**Model: CL1411R COLOUR TELEVISION**

**Subject:** TUNING SELECTION  
**Fault:** CHANGE OF MICRO PROCESSOR.  
**Symptom:** CHANGE OF MICRO PROCESSOR  
**Cause:** ADDITION OF FRENCH LANGUAGE OSD  
**Cure:** NEW MICRO PROCESSOR VERSION  
DW167MN05 IS INTERCHANGABLE WITH  
ORIGINAL DW167MN04.  
TYPE DW167MN05: PART No DE1DW167MN05

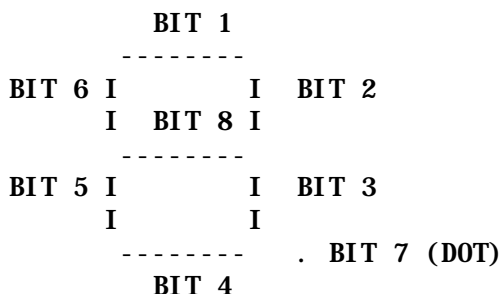
**NOW PRESS THE "VOLUME PLUS" BUTTON TO  
GO TO OPTION BYTE 1. THE CHANNEL  
INDICATOR DISPLAY WILL SHOW "1" IN THE  
LEFT HAND DIGIT WINDOW, AND YOU WILL  
NEED TO SELECT THE CORRECT BITS IN THE  
RIGHT HAND WINDOW USING THE CHANNEL  
BUTTONS ON THE HANDSET.**

**THE BITS ARE NUMBERED THUS ....**  
..... (CONT)

**Subject: TUNING SELECTION**  
**Fault: IC1501/2 SAA1293A-03 PROGRAMMING**

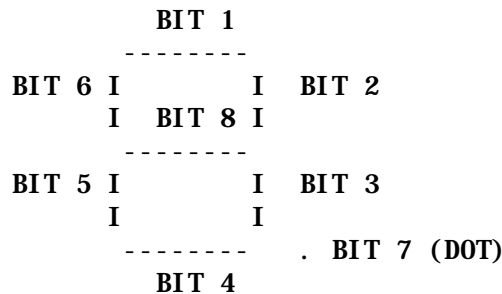
**Symptom:** MEMORY LOSS.  
**Cause:** CORRUPTION TO MICRO / EEPROM  
**Cure:** FIT IC1501 TYPE No SAA1293A-03  
 P/N T900549 & IC1502 P/NO E730002  
 WHEN FITTED THE PROGRAMMING METHOD  
 DIFFERS FROM THAT OF THE ORIGINAL AND  
 SHOULD BE DONE AS FOLLOWS. .... (CONT)  
 YOU WILL REQUIRE THE REMOTE CONTROL  
 HANDSET (FOUR BATTERY VERSION ONLY)  
 TO EASE PROGRAMMING, A SWITCH CAN BE  
 ADDED TO THE HANDSET.  
 1) IF IC1 IS TYPE SAA1250, CONNECT THE  
 SWITCH BETWEEN PINS 15 & 23.  
 .... (CONT)
